**Mine Unit 1 Restoration Report**  
**Crow Butte Uranium Project**

**January 10, 2000**

**United States Nuclear Regulatory Commission**  
**Source Materials License SUA-1534**

FIGURE 1. Unit 1 Radium-226 Measurements

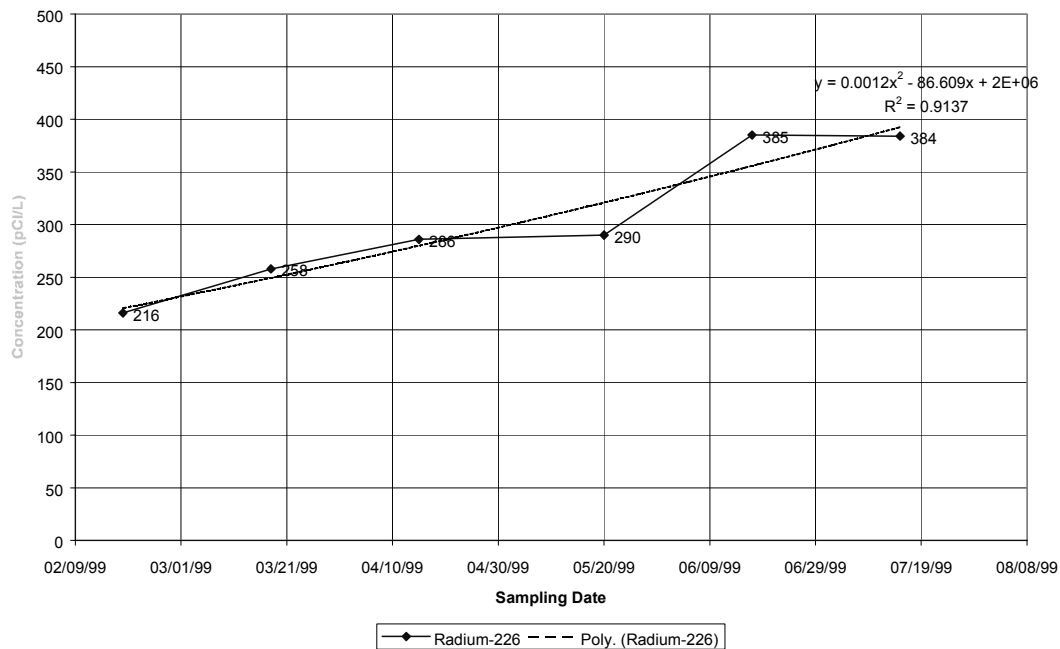
1. **Finding:** Staff’s analysis indicates that concentrations of ammonium, iron, radium-226, selenium, total dissolved solids, and uranium show strongly increasing concentration trends over the stability monitoring period. These trends indicate a reasonable likelihood that license limits would be exceeded in the near future. Other constituents appear to have reached stability, or exhibit such a weakly increasing trend that stability is not a concern. Figures 1, and 2, provide examples of strongly increasing concentration trends in the monitored data during the stability monitoring period. These increasing trends represent a particular concern when a constituent has been restored to the secondary restoration goal, as these two examples were. The secondary restoration standards are greater than the pre-operational baseline concentrations, but are considered protective of the adjacent aquifer beyond the limits of the U.S. EPA designated aquifer exemption boundary. Increasing trends that indicate a potential future exceedance of baseline limits do not represent an immediate concern, since the secondary limits are higher than the baseline limits and are considered protective. Figures 3, and 4, illustrate two constituents that appear to have stabilized during the stability monitoring period. Although Figure 3, shows an increasing trend, this trend is not significant. Figure 4 shows a strongly increasing trend in the early measurements, but the trend dissipated by the time the later data were collected.

2. **Conclusion:** The data provided by the licensee in the original submittal (CBR, 2000B), and the supplemental data provided in response to NRC's Request for Additional Information (CBR, 2001), has not demonstrated that these concentrations have reached a level of stability that will assure continued compliance with the restoration goals. The Unit 1 restoration does not appear to have stabilized over the six month stabilization period provided by the licensee, and the licensee has not demonstrated that the restored ground-water concentrations in Unit 1 will remain stable and will not exceed the established license limits at some point in the future.

1. The licensee's request for Unit 1 wellfield restoration approval should be denied.
2. Decommissioning of Unit 1 should not proceed at this time.
3. Stabilization ground-water monitoring in Unit 1 should be restarted immediately at the monitoring locations described in the January 10, 2000, Restoration Report. The ground-water should be sampled and analyzed for the constituents listed in License Condition 10.3B, SUA-1534, on a schedule of at least 14 days apart. The wellfield restoration shall be considered stable if four consecutive sampling episodes show no strongly increasing concentration trends for all monitored constituents, on a wellfield average, as described in Section 6.1.3, "Standard Review Plan for *In Situ* Leach Uranium Extraction License Applications," NUREG-1569.
